ABBREVIATED PLAT AGENDA ASSEMBLY CHAMBERS 350 EAST DAHLIA AVENUE, PALMER

April 23, 2025

ABBREVIATED PLAT: PRESTON HLS L15A B3 SUBDIVISION

EARLES LOT 1 AND LOT 2

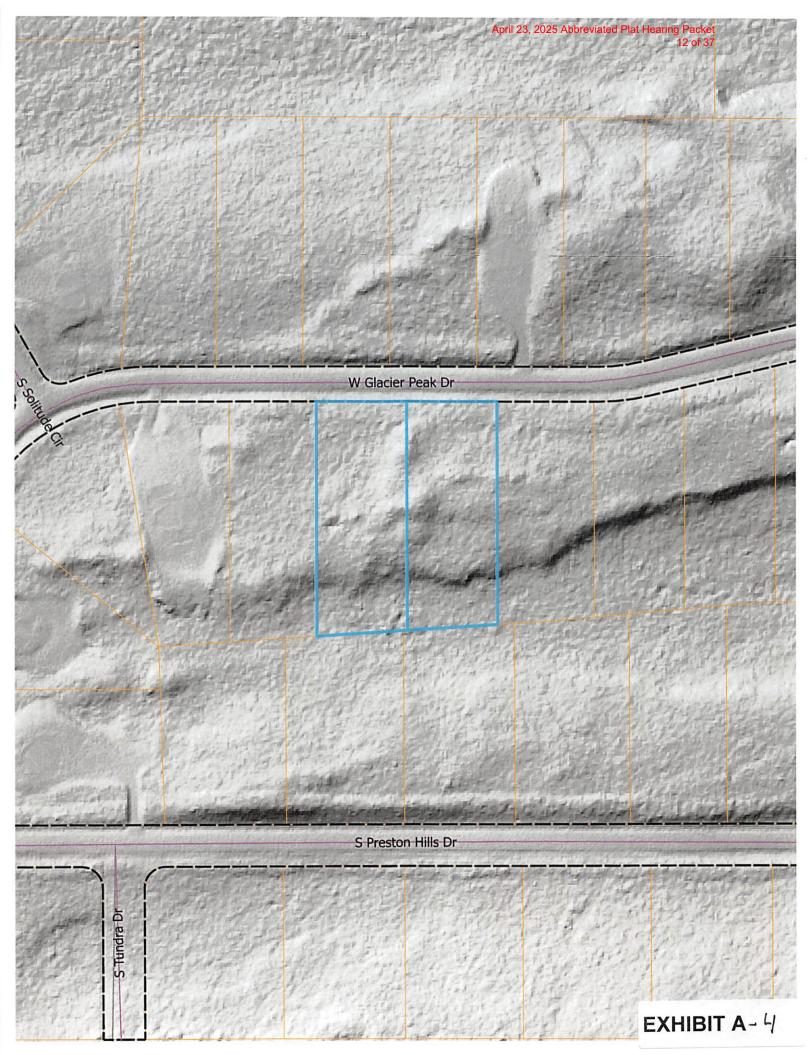
Thank you for bringing this project to our attention and for allowing us to comment. The Corps of Engineers does have a comment regarding the proposed Preston Hills L15A B3. Based on aerial imagery and the Matanuska-Susitna Borough (MSB) Wetlands Mapper, it appears that there may be aquatic resources in the bottom middle portion of the proposed lot where Lots 14 and 15 currently meet.
